Clarification No.2

Tender No.PROC/LF/PT/P&P/DKN-17295/18

Description - Supply, Fabrication & Testing of Sulphur Condenser

P0005440-2

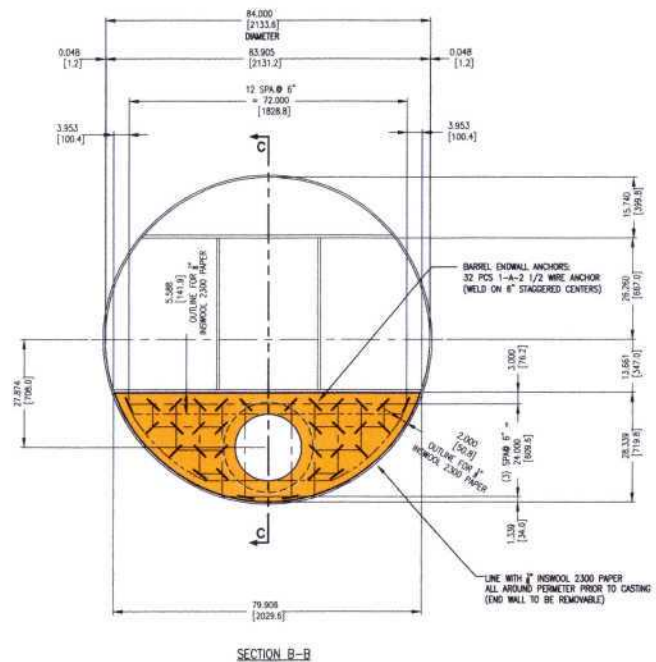
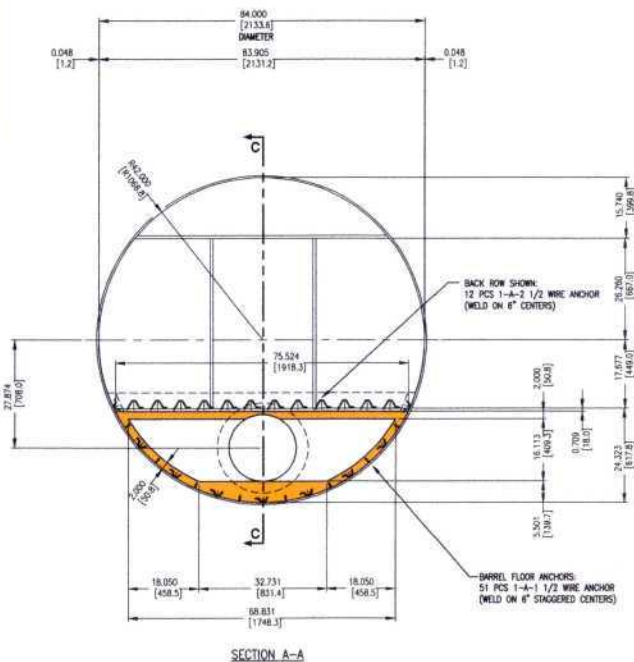
2- 02 Nos Drawings for refractory details is attached.
